Addendum #04 for RFB #941400-01

Project Name: DPS DSM New Fleet Building Renovations

Date: January 21, 2024

Addendum #04:

a. AD102 OHIO DEMOLITION PLAN – AREA A

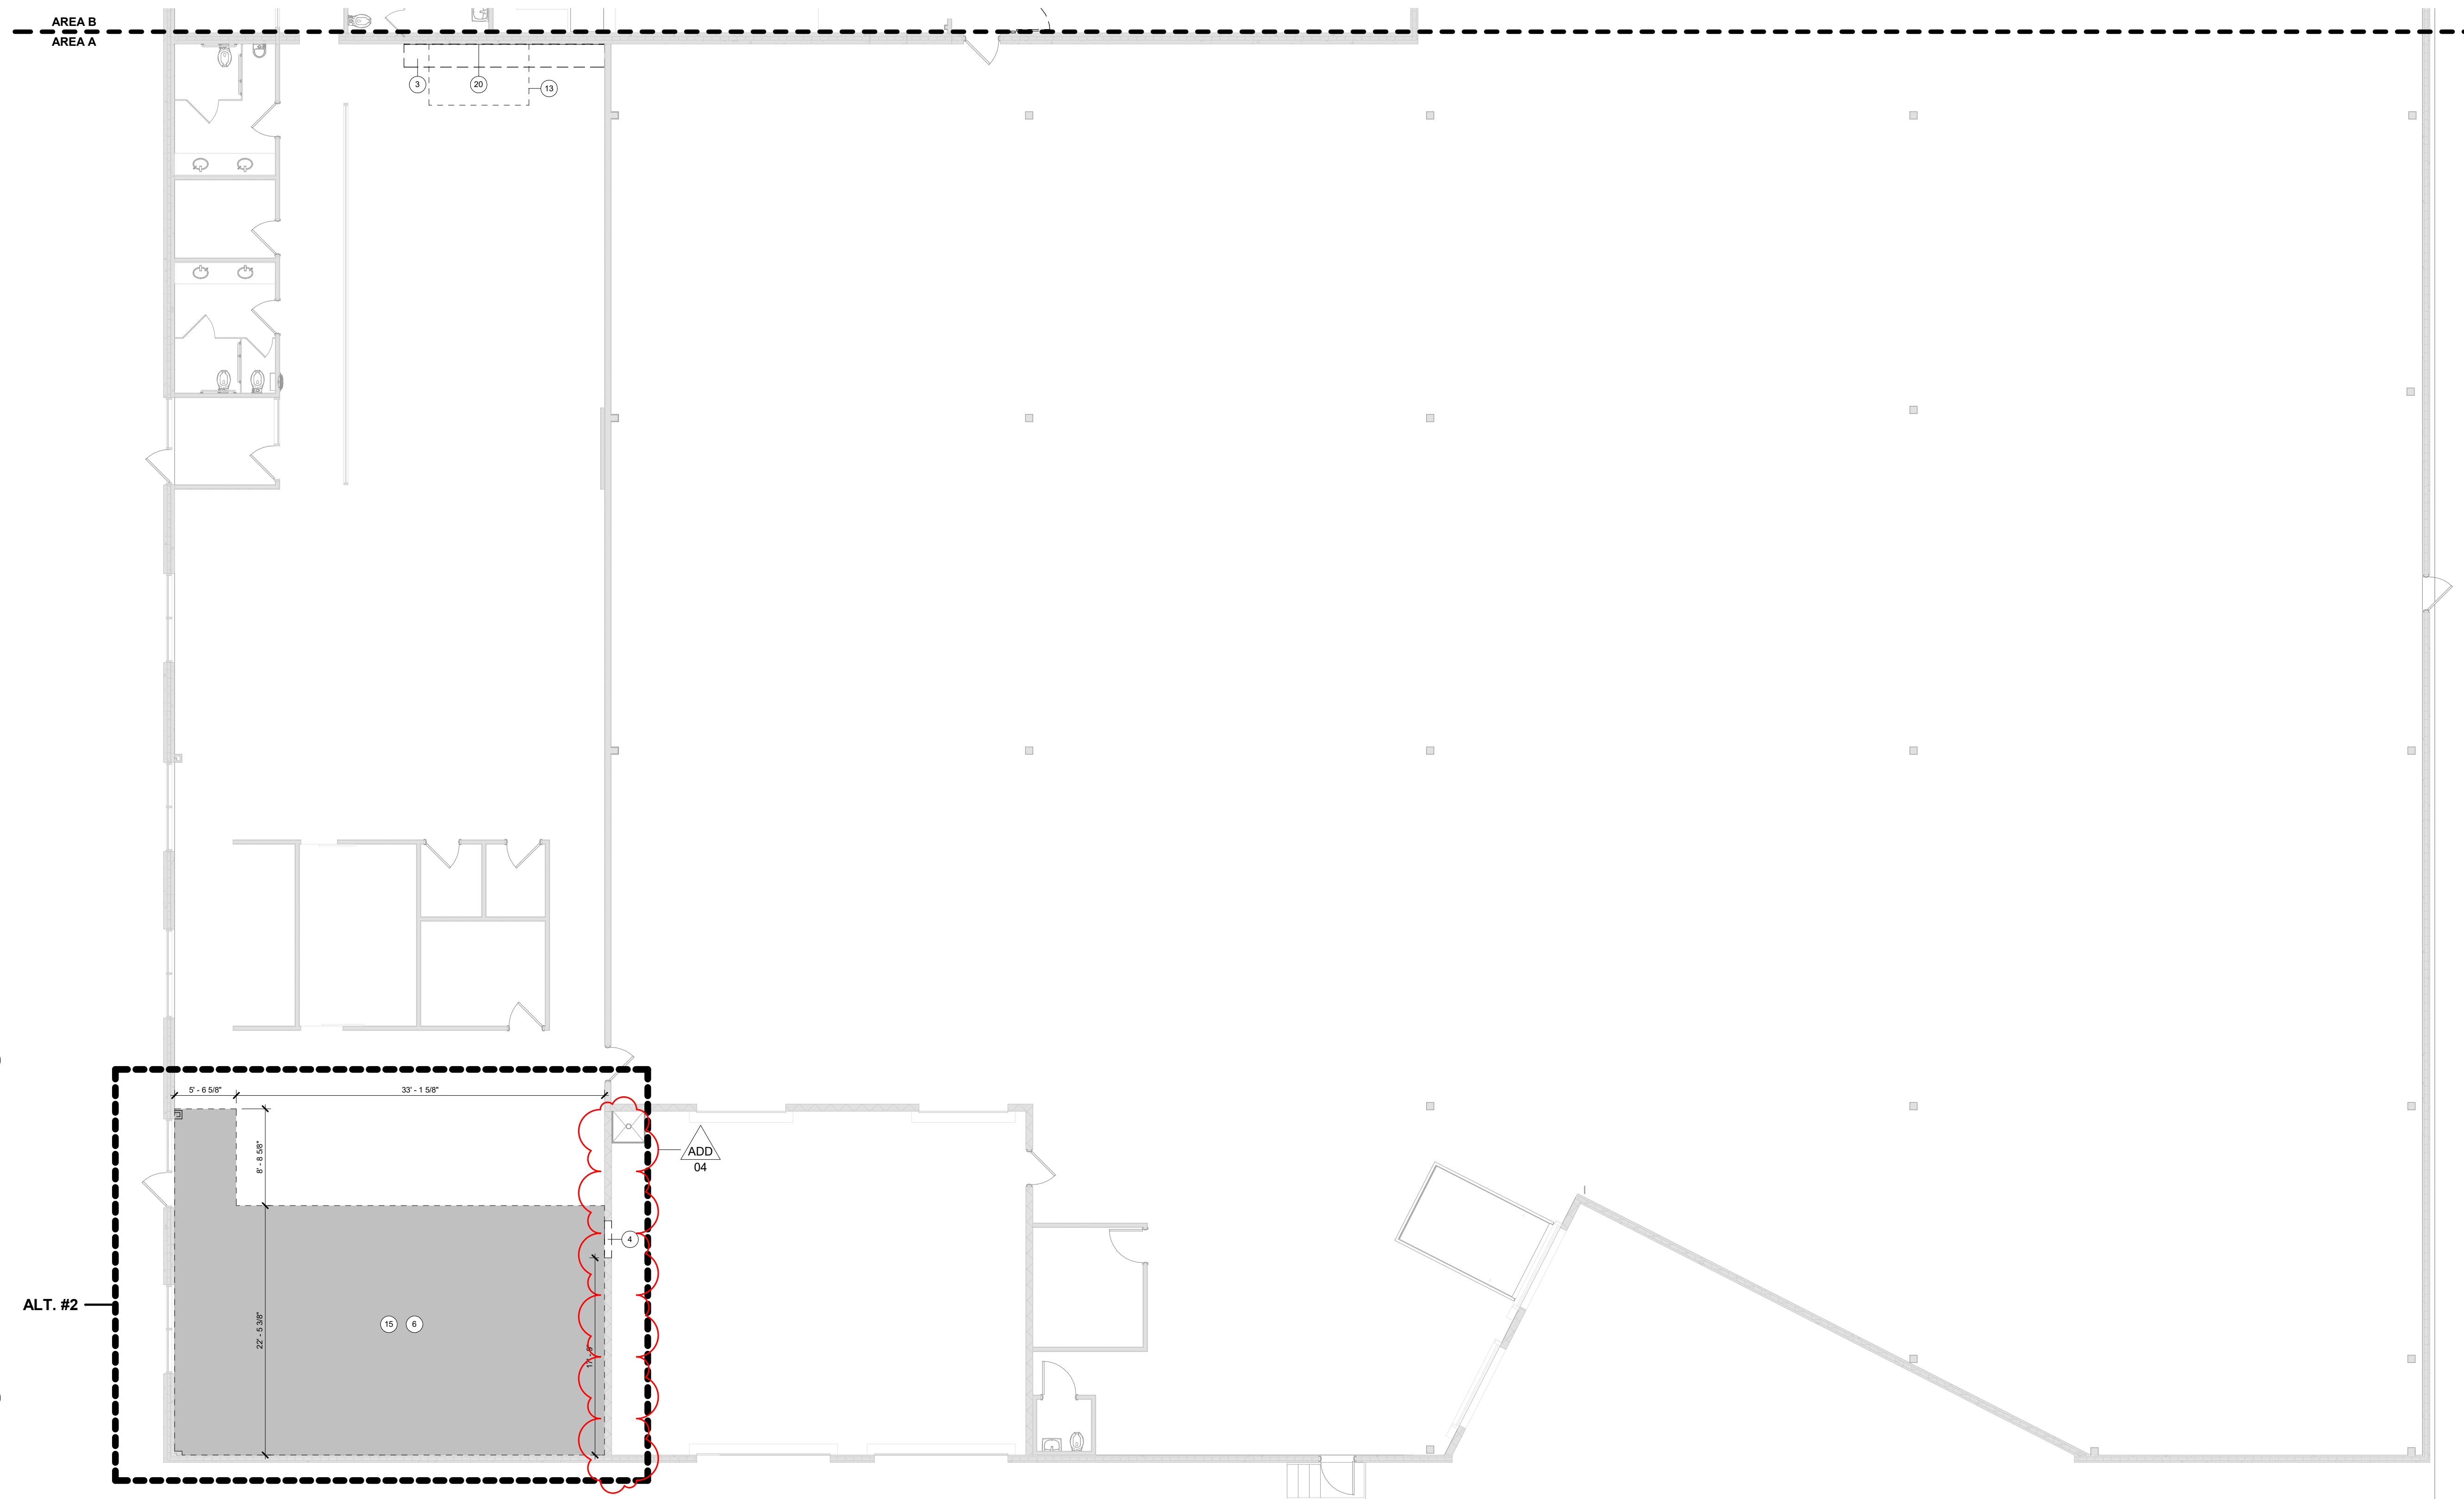
- i. Demolition Notes
 1. **REVISE** keynote 4.
 2. **REVISE** existing wall between Garage & Open Office to show as CMU.
